STATE OF NORTH CAROLINA  
DEPARTMENT OF TRANSPORTATION

April 27, 2010

SUBJECT: Lee County, US 421-NC 87 Sanford Bypass from existing US 421 northwest of Sanford to existing NC 87 southeast of Sanford (R-2417C) and from west of SR 1400 to west of US 1-15-501 (R-2417AA); T.I.P. Number R-2417C and R-2417AA; Federal-Aid Project STPNHF-421(2); WBS No. 34431.1.1

Attached are the modifications to the U.S. Army Corps of Engineers Section 404 Individual Permit 404 and N.C. Division of Water Quality Section 401 Individual Water Quality Certification for the above referenced project. All environmental permits have been received for the construction of this project.

Permit Drawing  
Sheet 24 of 41

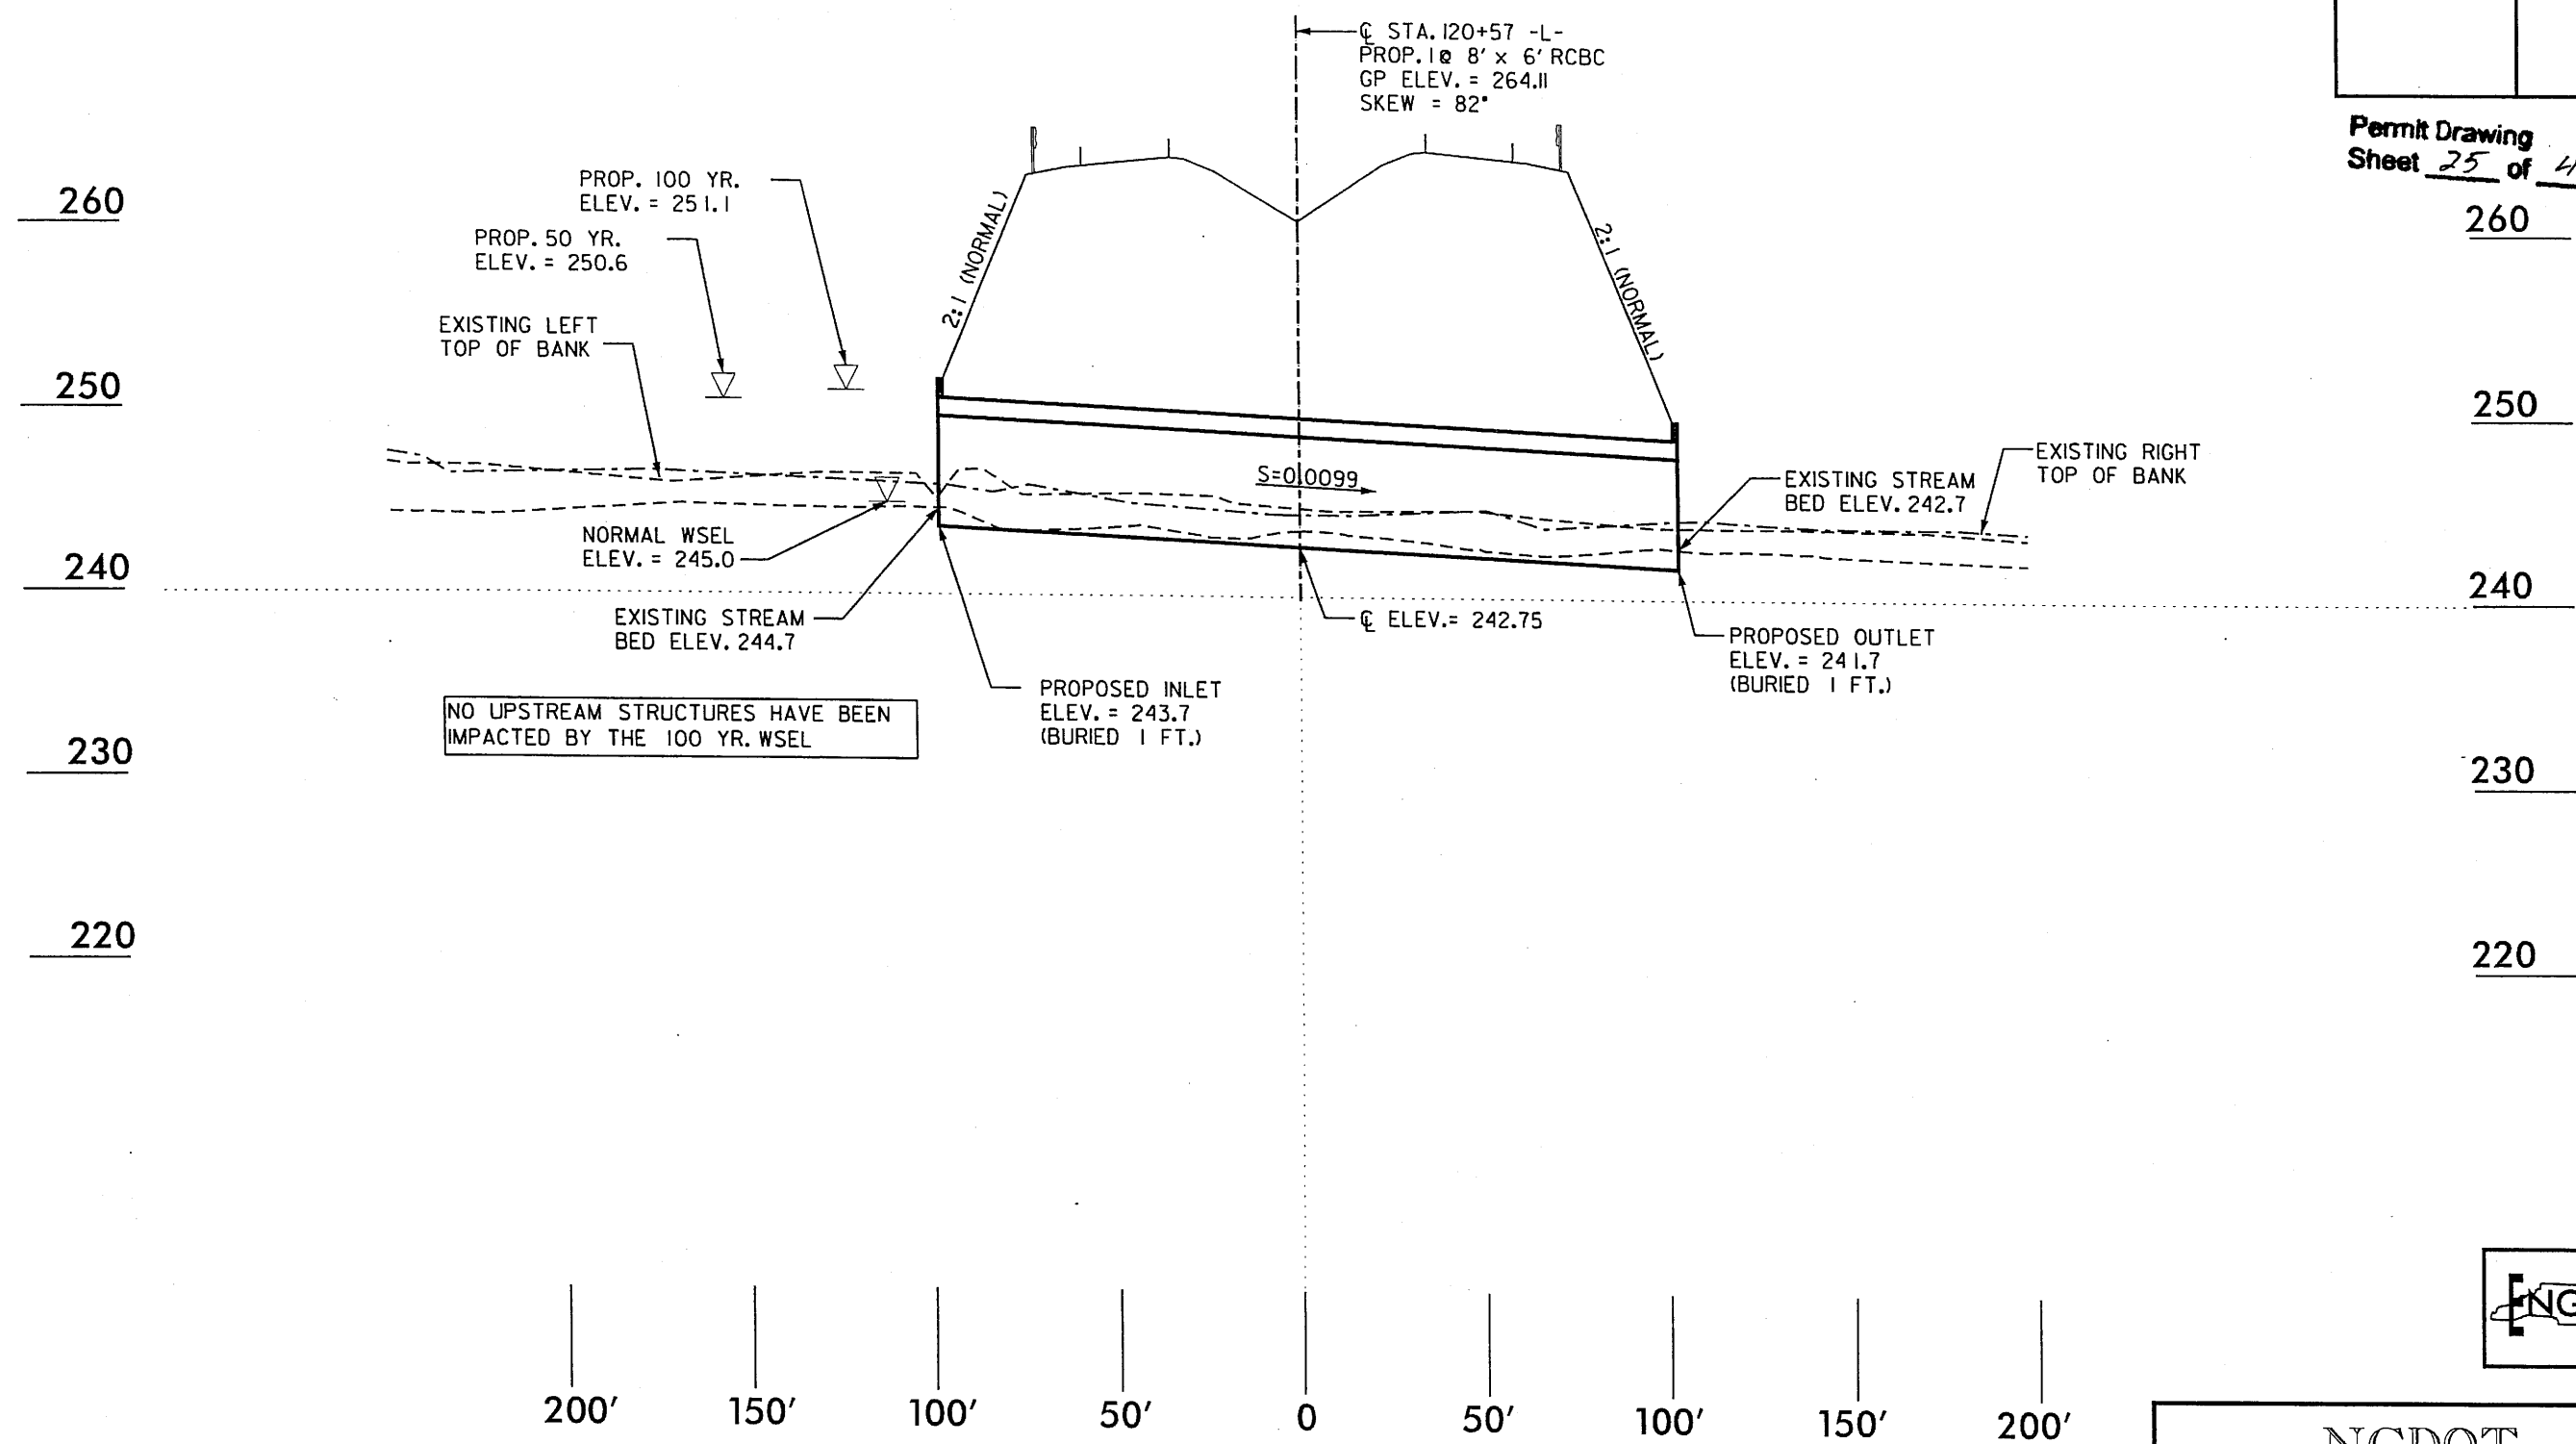
4. The stream is relocated to a ditch line at Permit Site #13 (Permit Drawing 24 of 31) and then conveyed into the natural stream. The ditch line appears to discharge to the natural stream at nearly a right angle. NCDOT is advised that if stream bank destabilization occurs as a result of the ditch line alignment, corrective actions to stabilize the stream will be required.

Permit Drawing  
Sheet 26 of 41

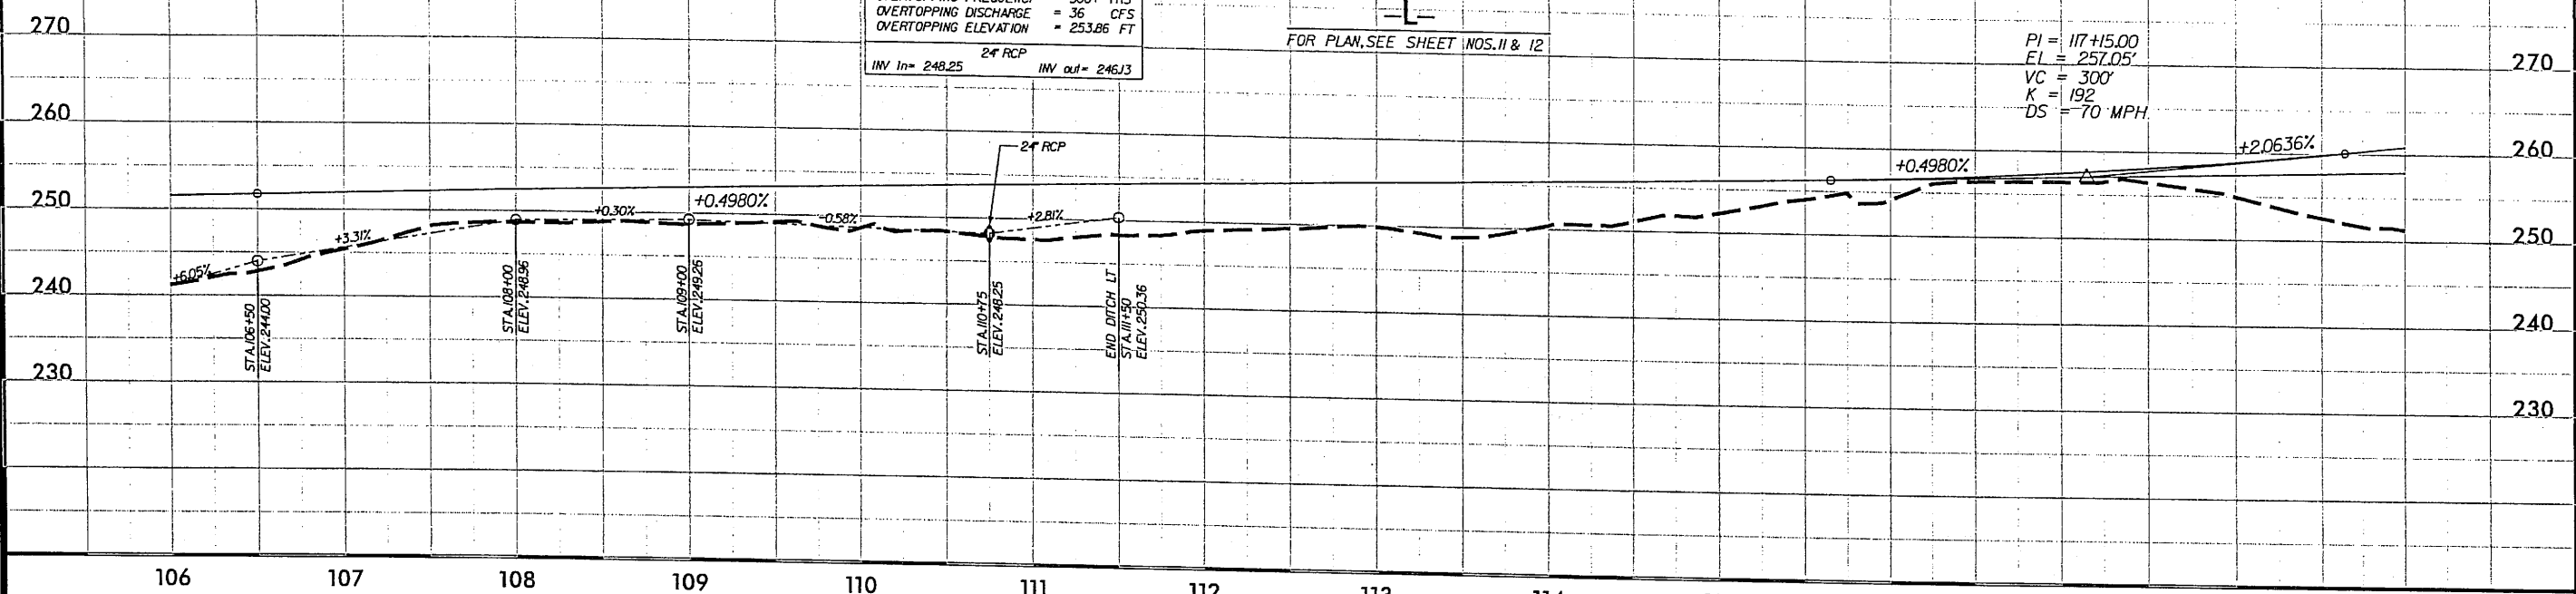
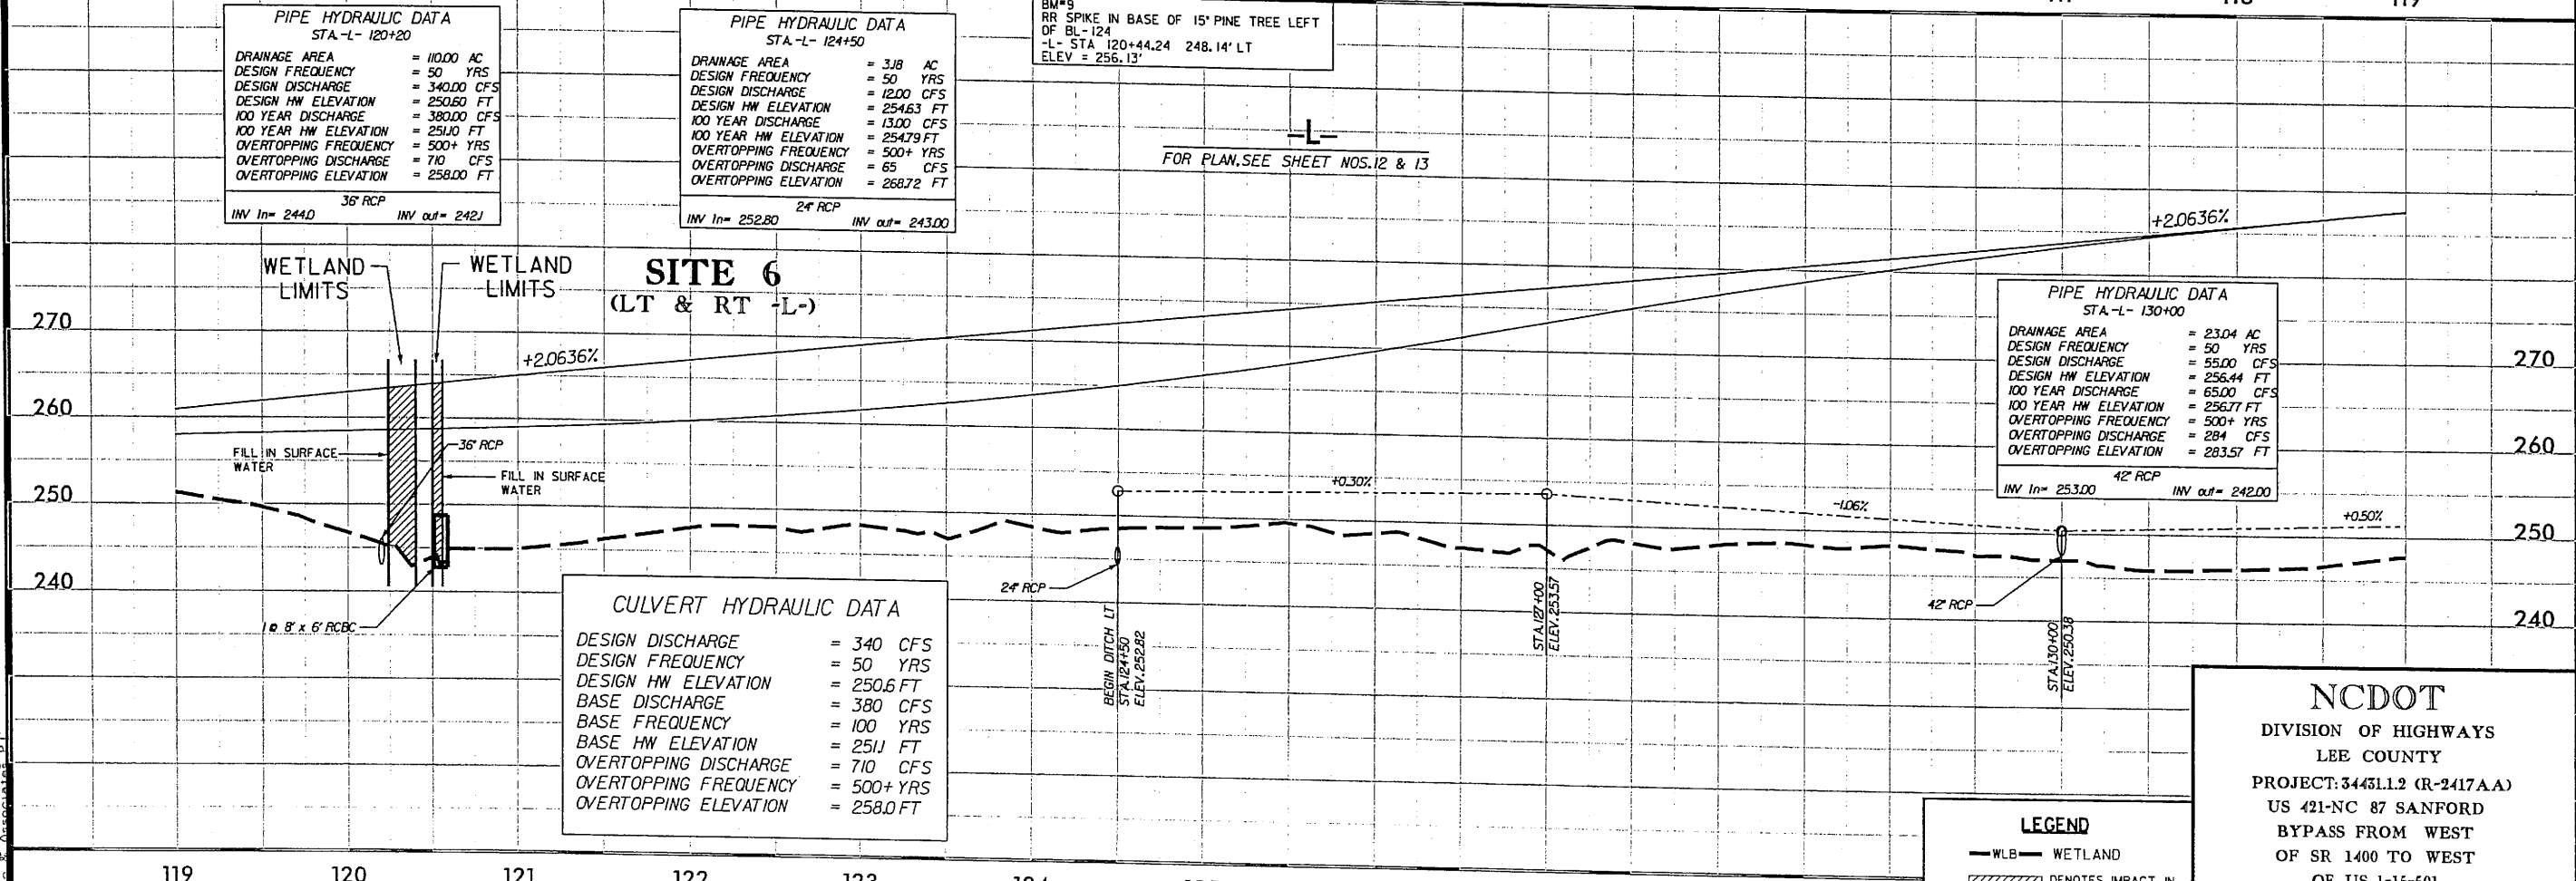
5. Two (2) overflow culverts will be installed at Permit Site #5 (Permit Drawing 26 of 31). An "overflow channel" is depicted on the outlet end of the overflow culverts. Per NCDOT staff, no excavation or other earthwork will be required to tie the "overflow channel" into the existing stream. If excavation or other earthwork is required, on the streambanks or in the stream, to provide a connection from the overflow channel to the stream, a detail shall be provided to ensure that no additional jurisdictional impacts will be incurred and the stream will remain stable.
